ANN ARBOR HISTORIC DISTRICT COMMISSION

Staff Report

ADDRESS: 808 W Washington Street Application Number: HDC24-0188

APPLICATION: The applicant seeks HDC approval to rebuild a non-historic mudroom on the rear of the house in a footprint that is 24 square feet larger; construct a 23-foot-wide shed dormer on the south roof surface; and construct a 27'2" x 27'7" garage with a second floor accessory dwelling unit (ADU).

NEW WORK
PLANS

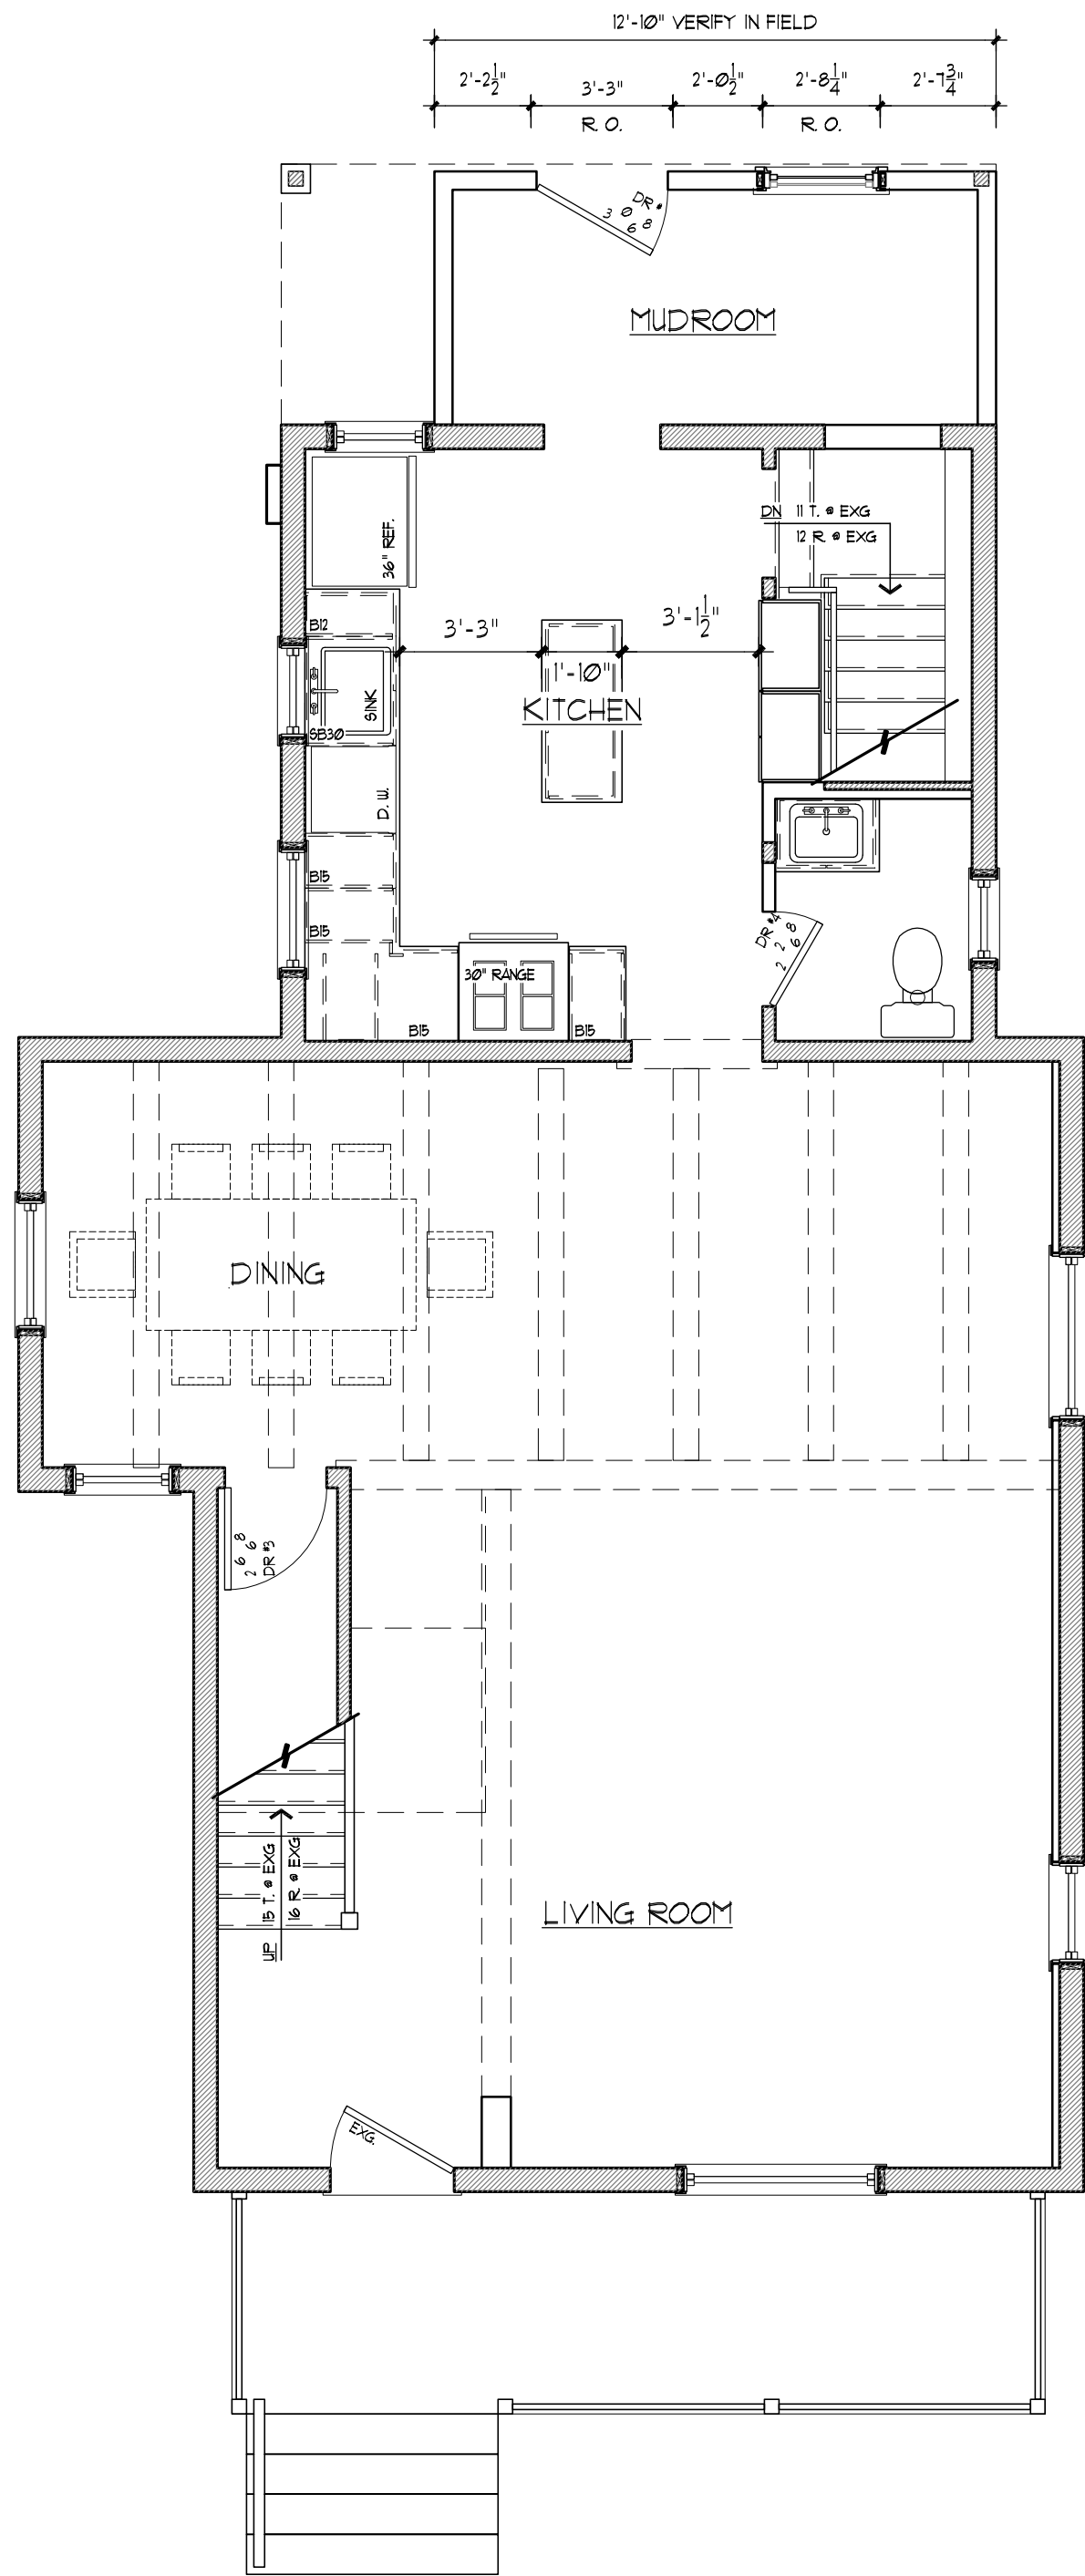
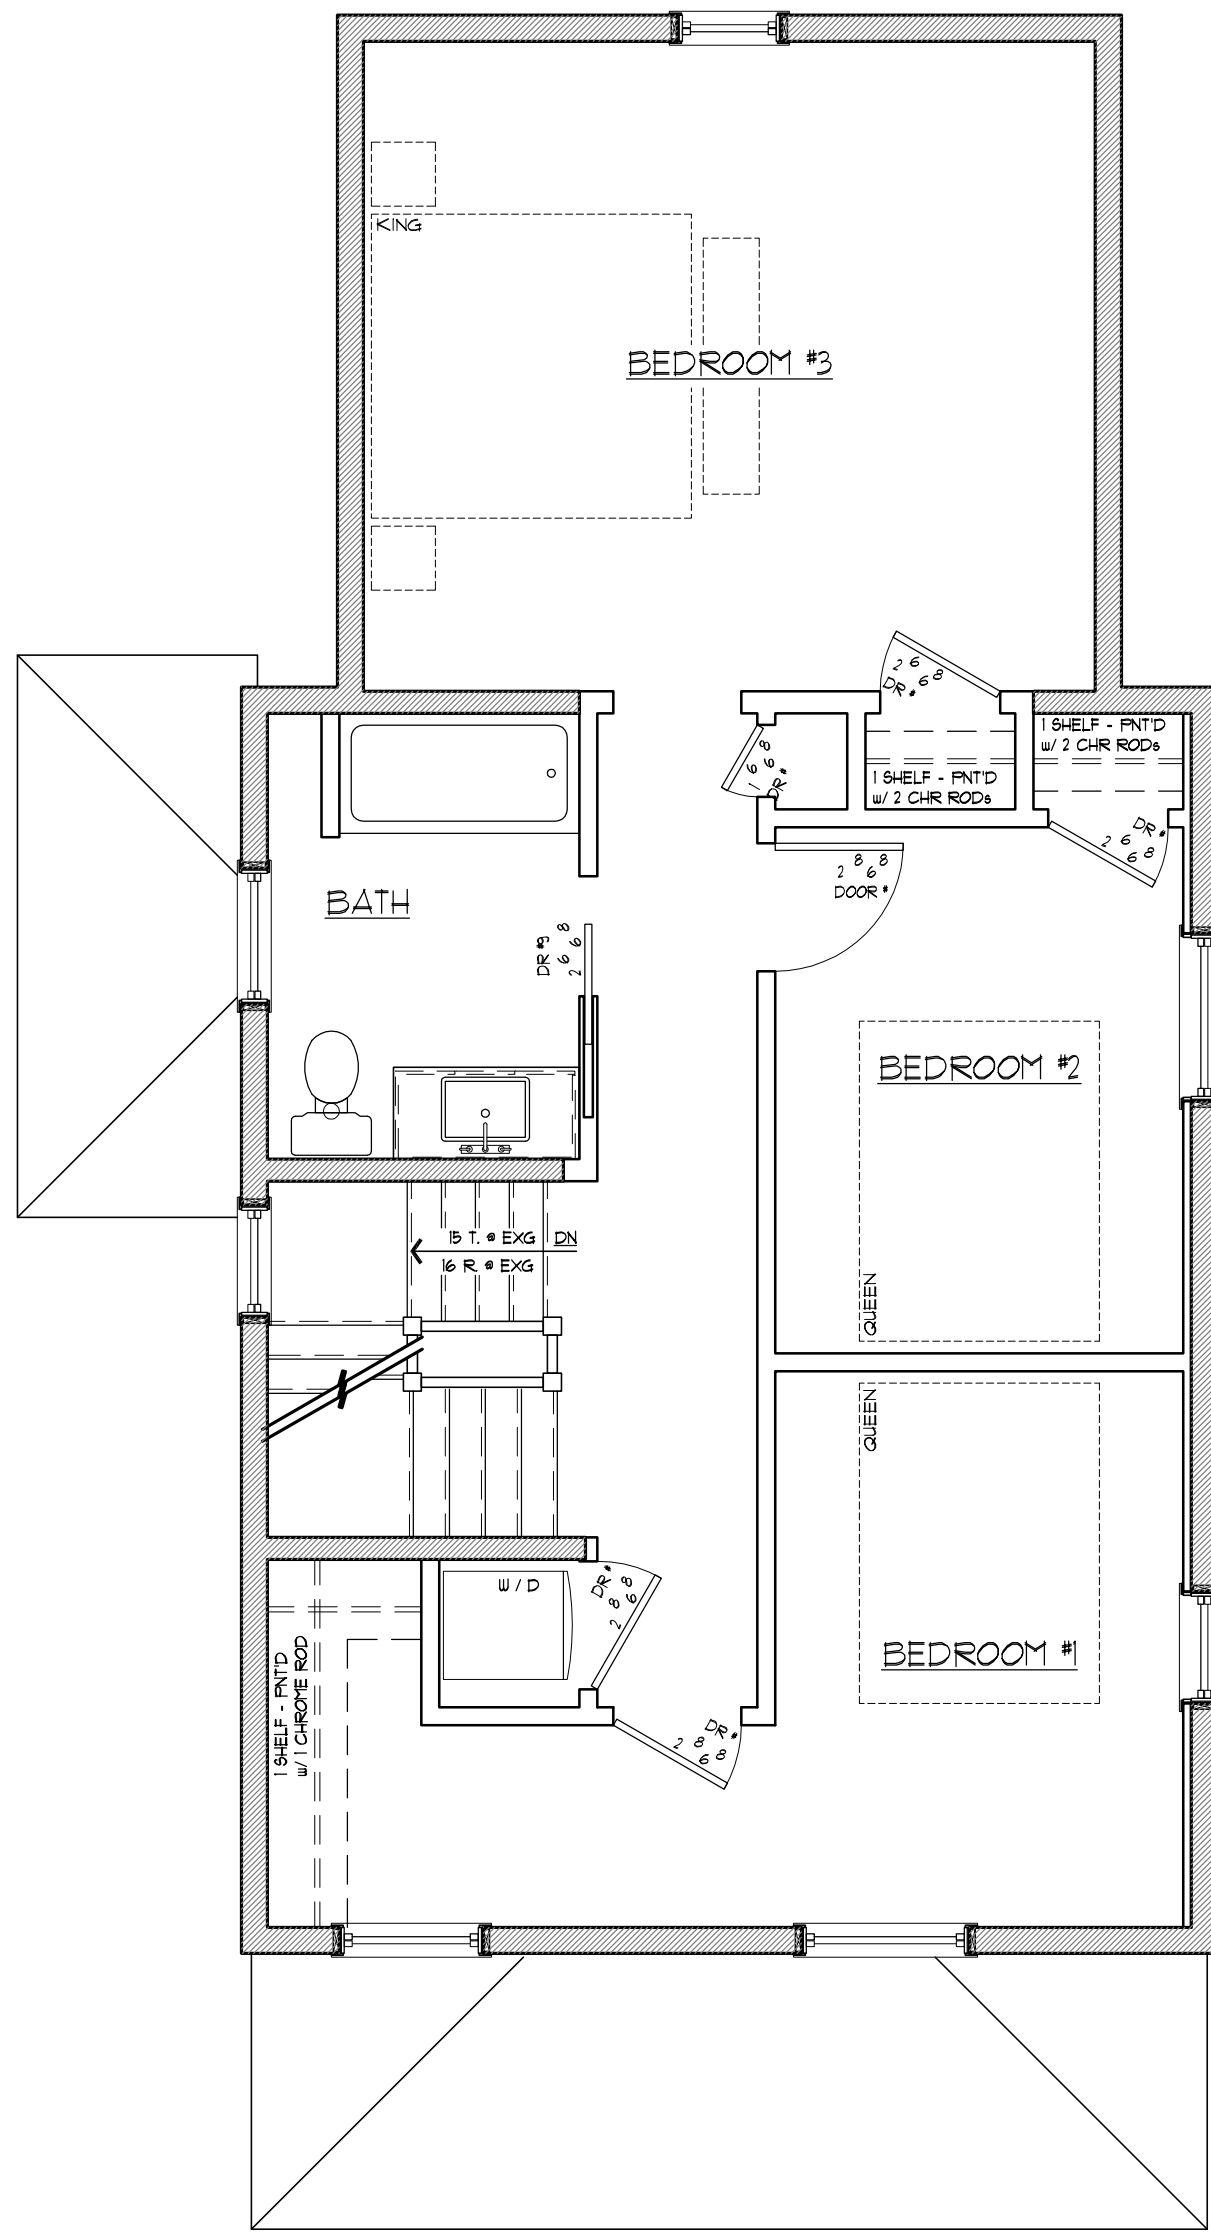
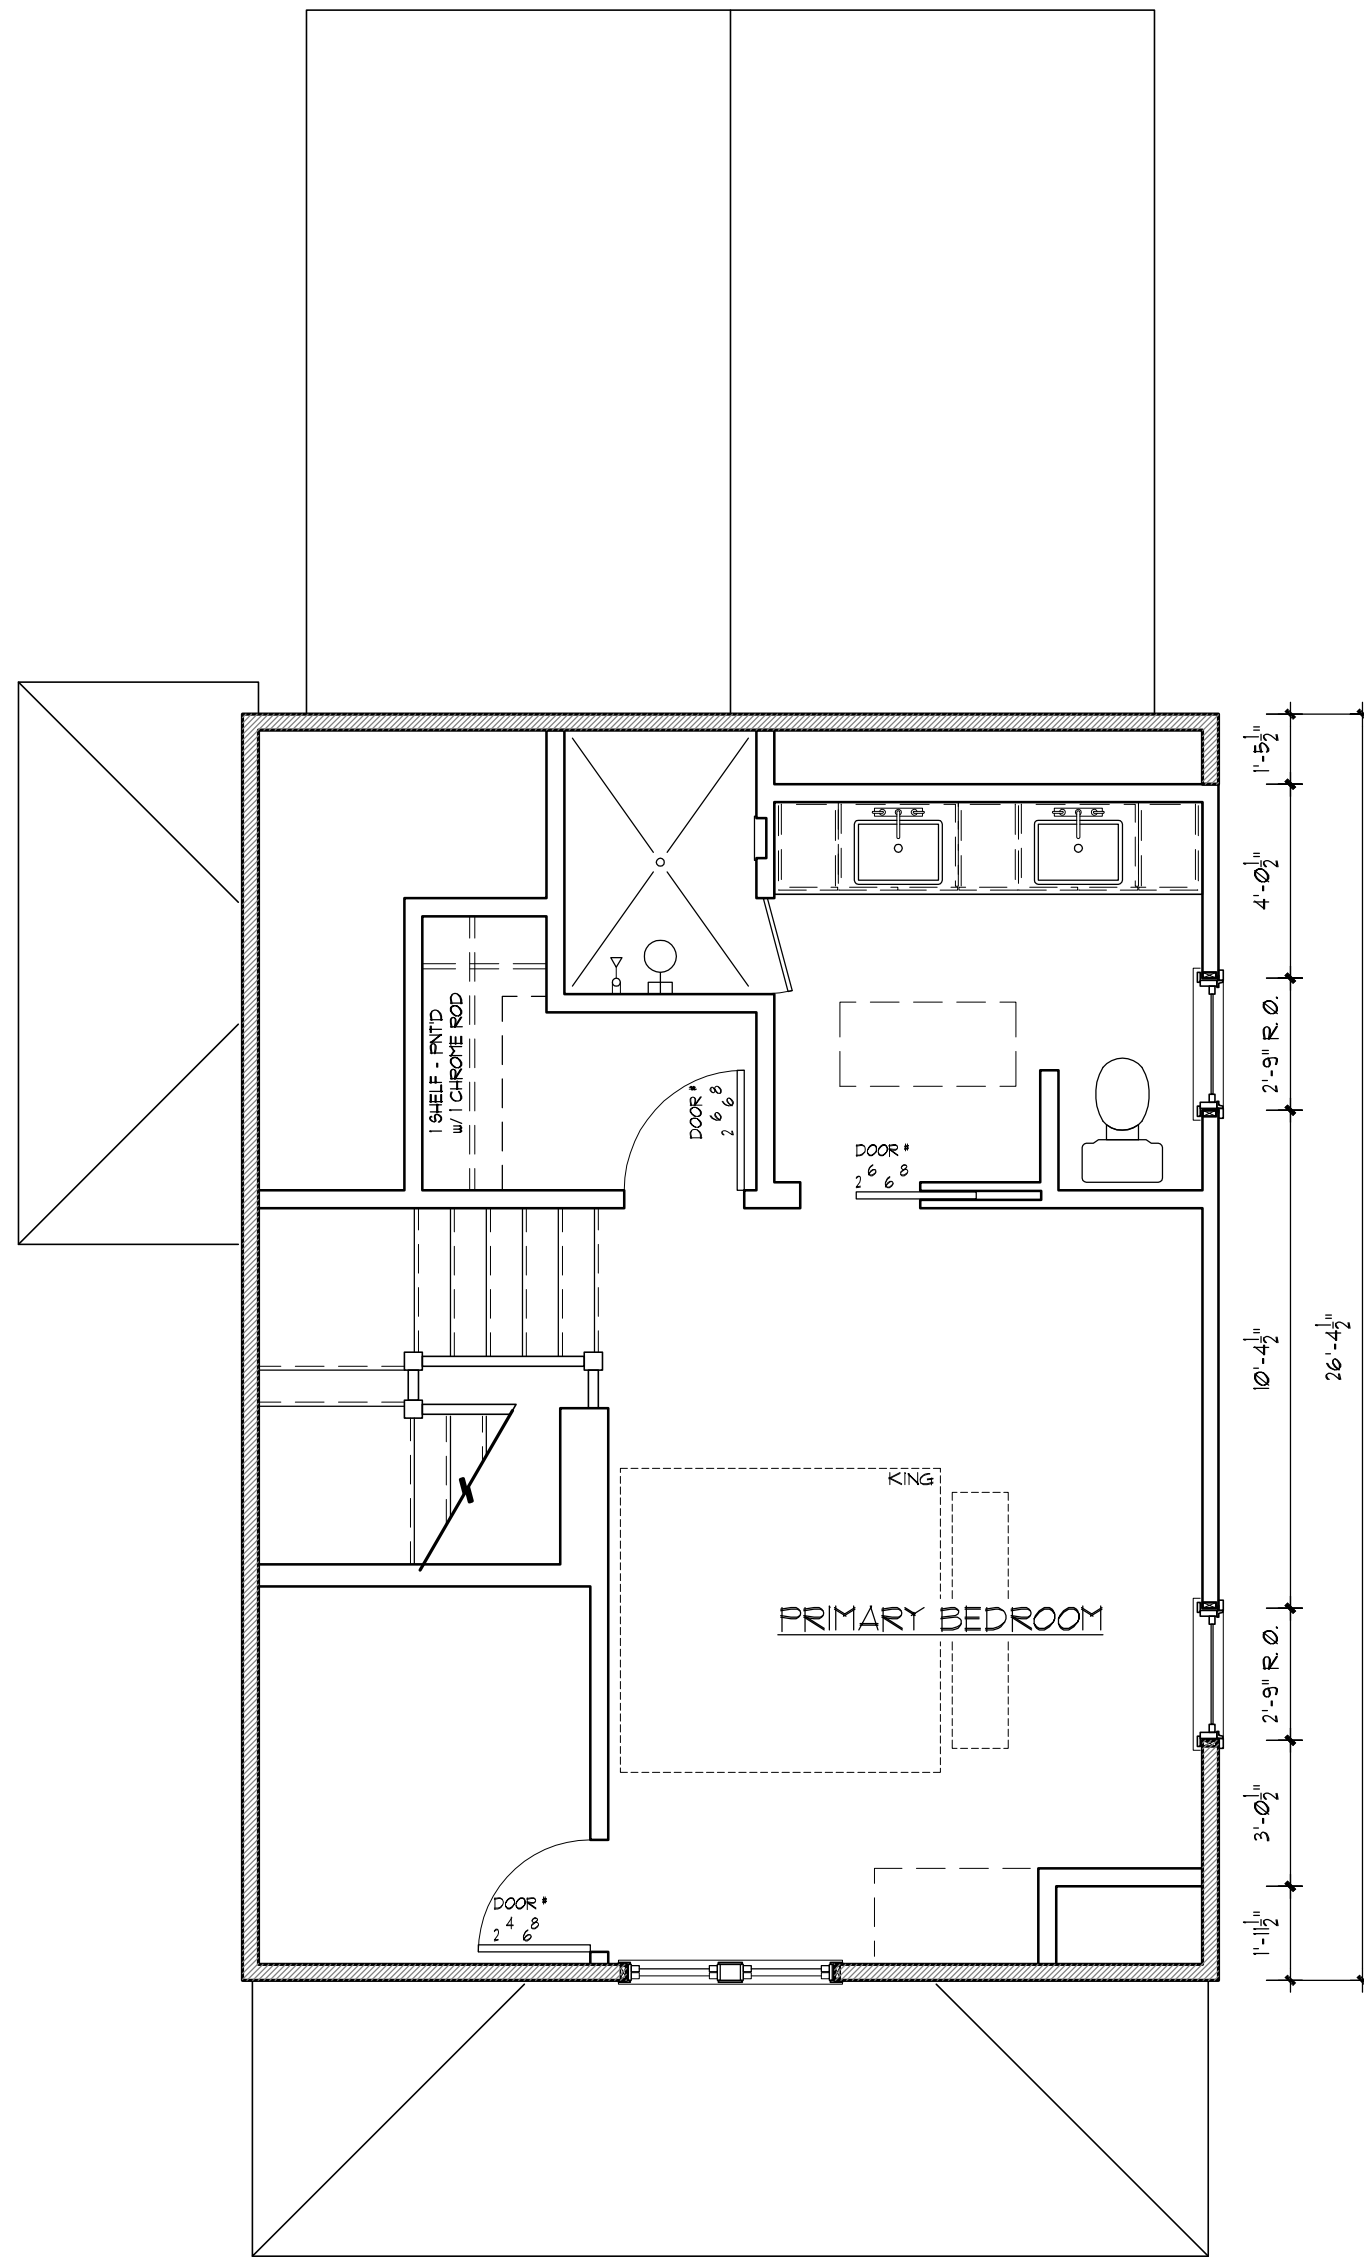
3. The application proposes to rebuild the existing mudroom in a 24 square foot larger footprint by infilling the northeast corner between the mudroom and the rear wing. The mudroom's new walls would be flush with those of the rear wing and the existing mudroom. The mudroom would have wood siding and corner boards that match those on the existing house. The rear/north elevation has one Marvin double hung window and a fiberglass door with a half-lite over two panels. The foundation will be reused with new concrete grade beams beneath the expanded corner. The addition will remove two back doors of unknown age, though from the photos provided they may be from the period of significance. At the Review Committee site visit, more information on the ages of these doors will be gathered. The roof deck, which is accessed by a window, will remain as is.

4. Staff believes that the mudroom work is appropriate. Though the wall is flush with that of the rear wing, it isn't the same height. To inset this corner adequately would significantly reduce the already small size of the addition. Staff appreciates that the window on the northwest corner of the rear wing, next to the existing mudroom and under the roof deck, has been retained. There may be some question about whether using matching siding and trim will confuse the historic record, but staff believes that the new window and door, and the foundation extension, will be adequate. It should be noted that using either a different width of wood siding or a cementitious siding would be more appropriate.
